DEPARTMENT OF INLAND FISHERIES & WILDLIFE			
				TITLE NEW OFFICE HEADQUARTERS							
				LOCATION AUGUSTA, ME							
				TITLE THIS DWG SIGNAGE DETAILS AND SCHEDULE							
				DRAWN BY: MJD							
				CHECK BY: CET							
				BY NO.							
				DATE 01/29/2025							
				REVISIONS

NO.	12/13/2025	ADDENDUM NO. 1	HMG	CET
DESCRIPTION	REVISIONS	DATE	01/29/2025

1 02/13/2025 ADDENDUM NO. 1

1 02/14/25 ADDENDUM 1		JSD	DRAWN BY: JSD	NO. DATE DESCRIPTION BY CHECK BY: SES	REVISONS	DATE 01/29/2025
DEPARTMENT OF INLAND FISHERIES & WILDLIFE				TITLE THIS DWG. UTILITIES PLAN		
TITLE NEW OFFICE HEADQUARTERS				LOCATION AUGUSTA, MAINE		
DRAWING NO. CU101				SHEET NO. 26 OF 239

2 BASEMENT MECHANICAL PIPING PLAN
MP104 SCALE: 1/8" = 1'-0"

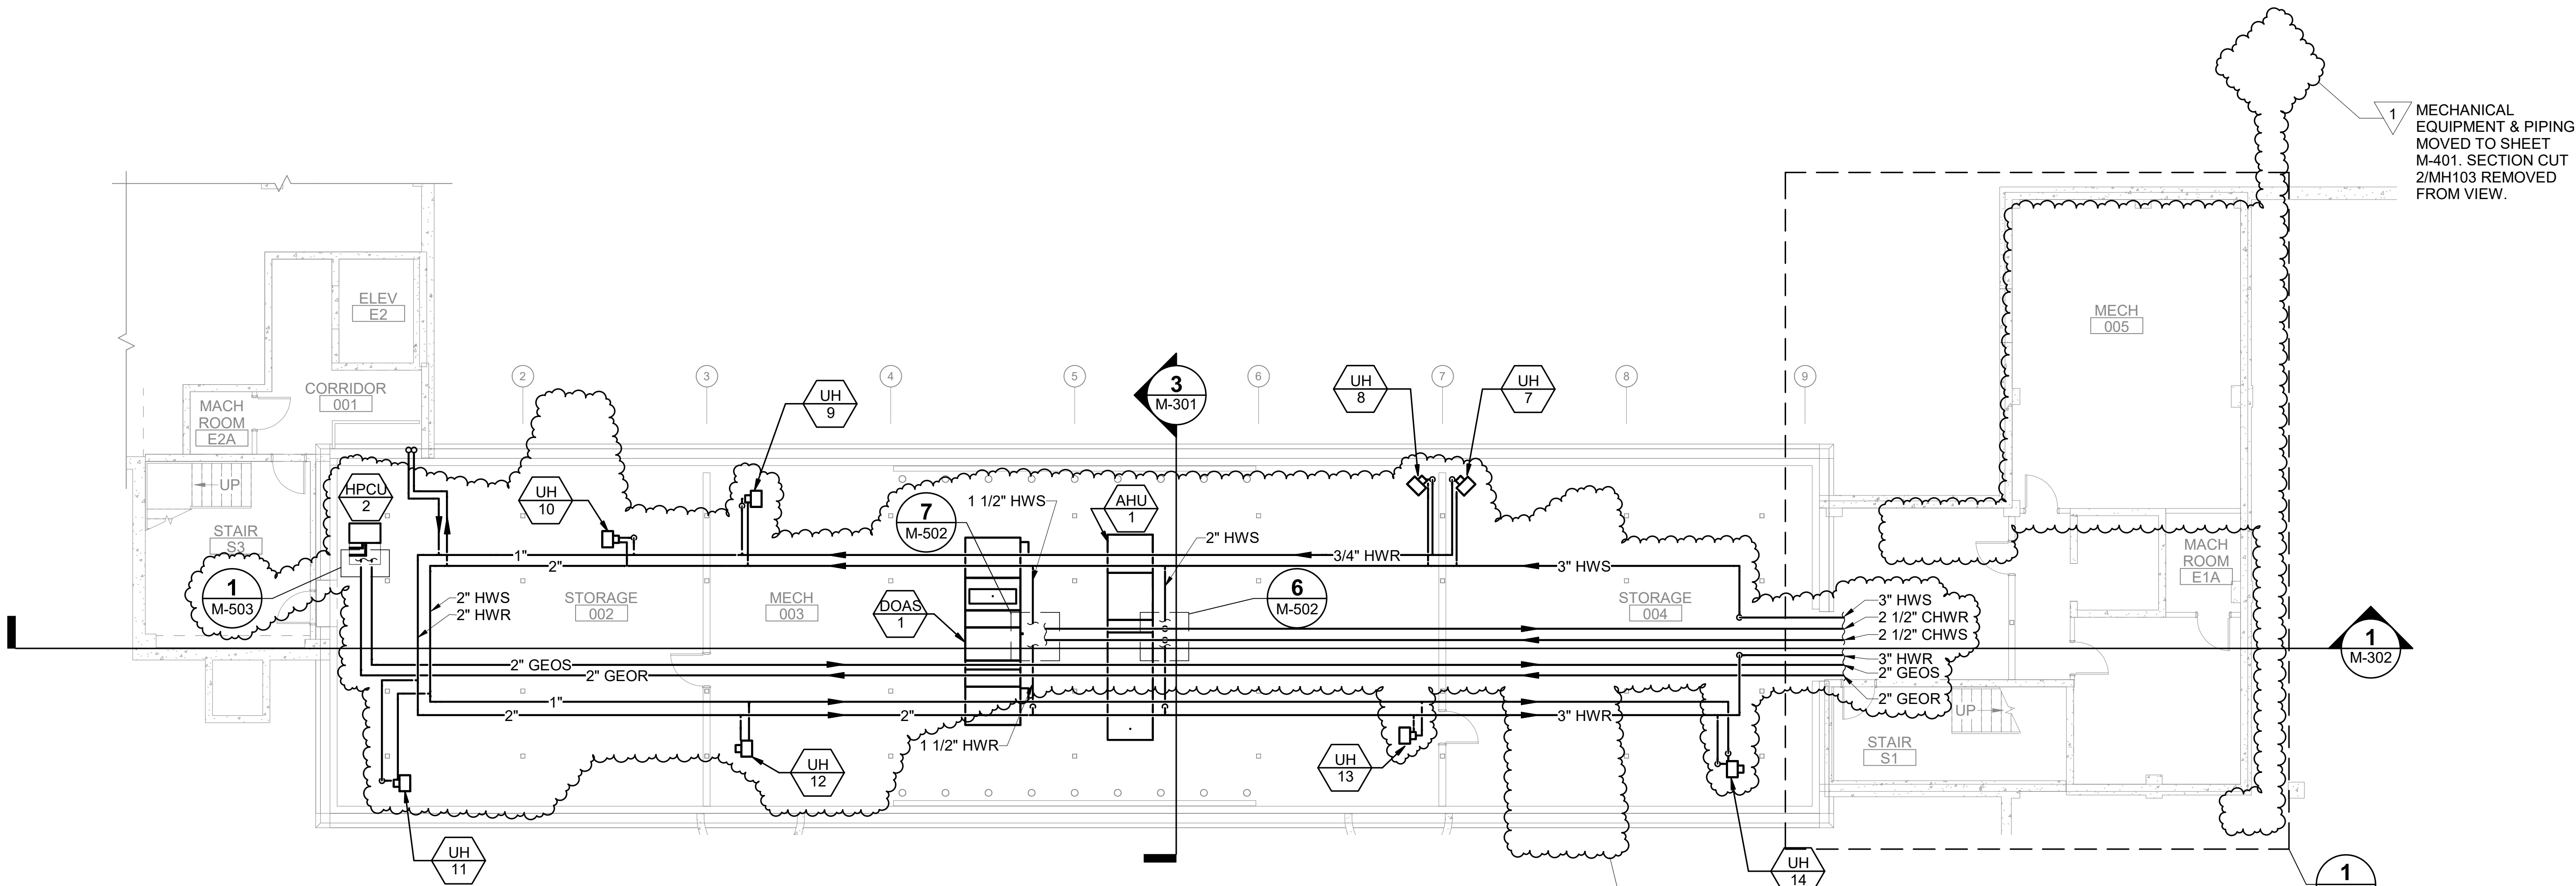
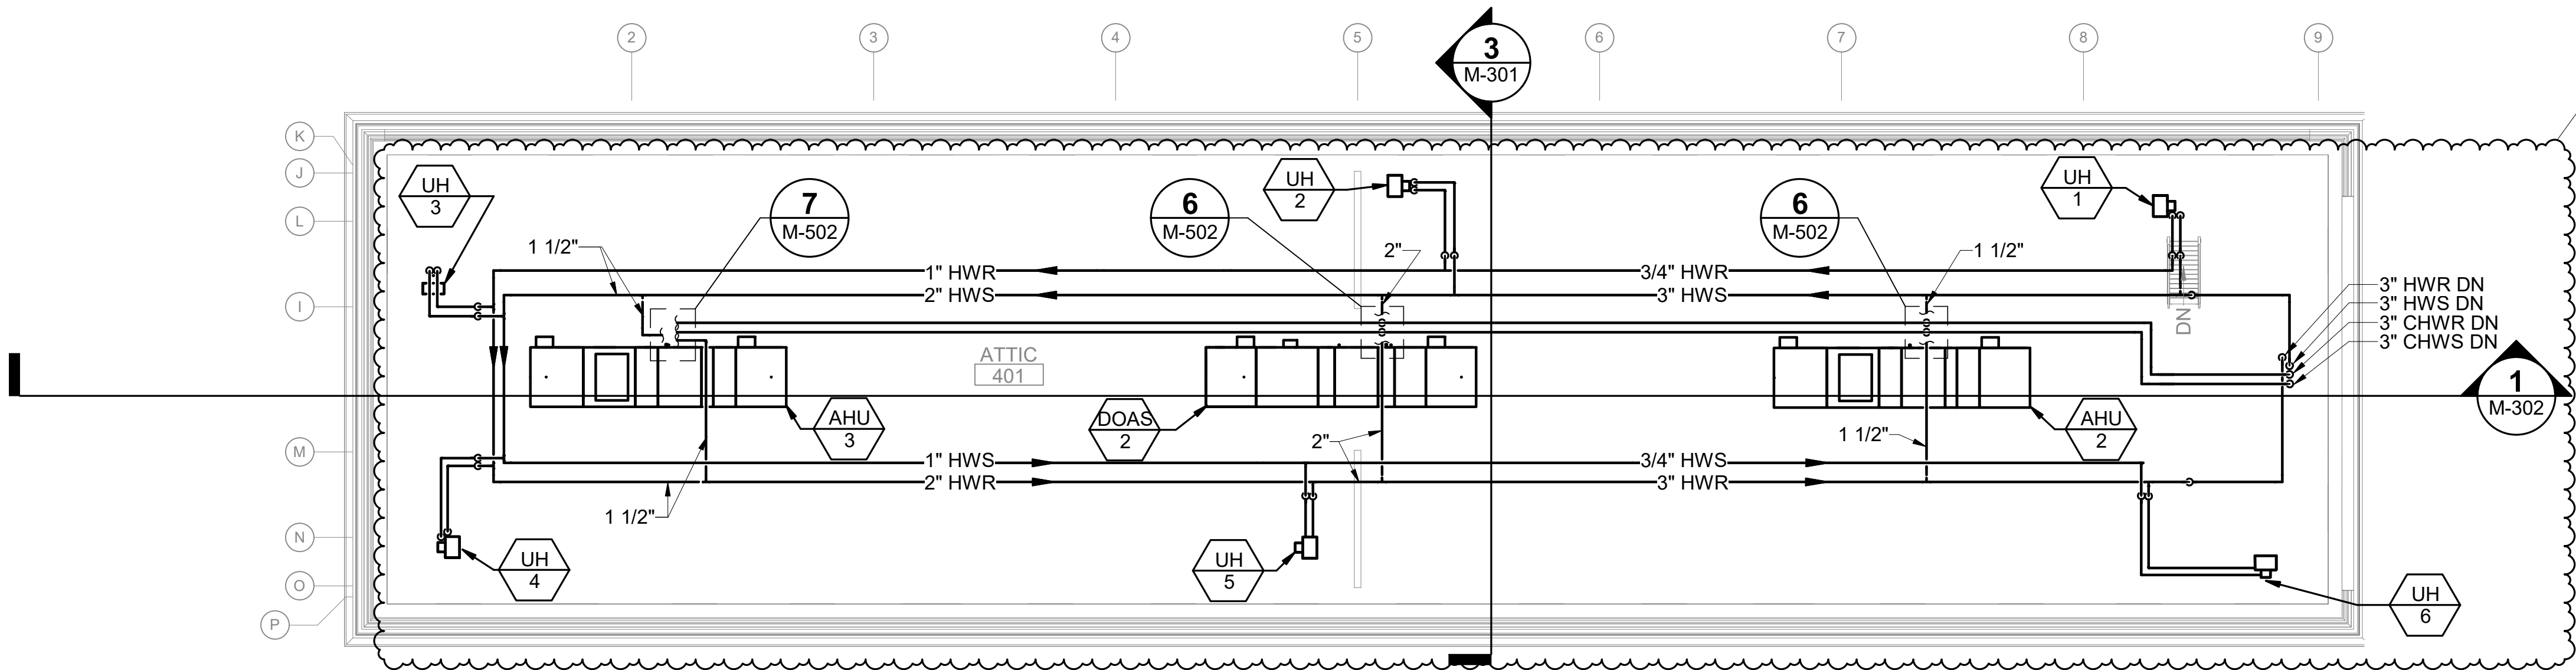
VAV BOXES REMOVED FROM MP SHEETS. VAV REHEAT COILS REMOVED. UNIT HEATER PIPING ADDED. HPCU-2 ADDED WITH ASSOCIATED GEOTHERMAL PIPING. PIPING CONNECTION TO AHU-1 AND DOAS-1 ADDED. PIPE SIZING ADJUSTED.
